D2 | FOR TENDER

WAVERLEY COMMUNITY SPACE OLIVE LANE

PROPOSED GROUND FLOOR PLAN

PROPOSED FLOOR PLAN

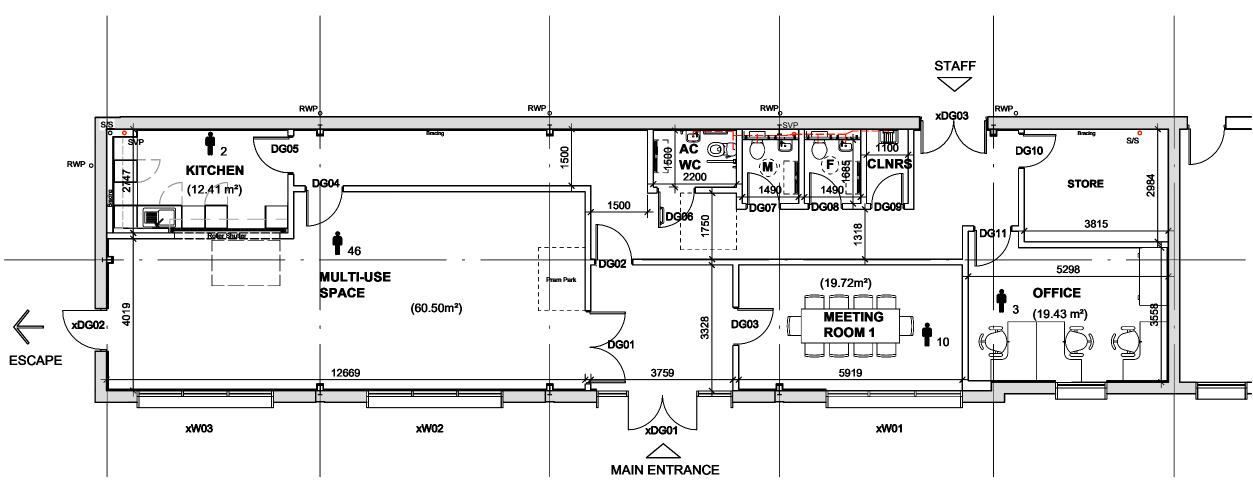
REVISION: T03	BY: RSP	CHECKED: MQ	DATE:	13/11/2
Tender Adde	ndum - Sliding	Partition Omitted		
REVISION: T02	BY: RSP	CHECKED: MQ	DATE:	23/07/2
Tender Adde	ndum - Kitche	n layout revised		
REVISION: T01	BY: RSP	CHECKED: MQ	DATE:	28/06/2
Issued for Te	nder			
REVISION: P04	BY: RSP	снескер: MQ	DATE:	13/06/2
Accessible V	VC amended to	comply with Doc M, Kitc	hen layout revi	sed. Flooi
areas update	ed,			
	BY: JT	CHECKED: MQ	DATE:	31/05/2
REVISION: P03				
Rear Fire exi		ed to be hung inwards. Se		educed to
Rear Fire exi	eting Room 3 a	rea. Sliding doors moved		
Rear Fire exi				25/01/2
Rear Fire exi increase Mee REVISION: P02	eting Room 3 a	rea. Sliding doors moved	to the left.
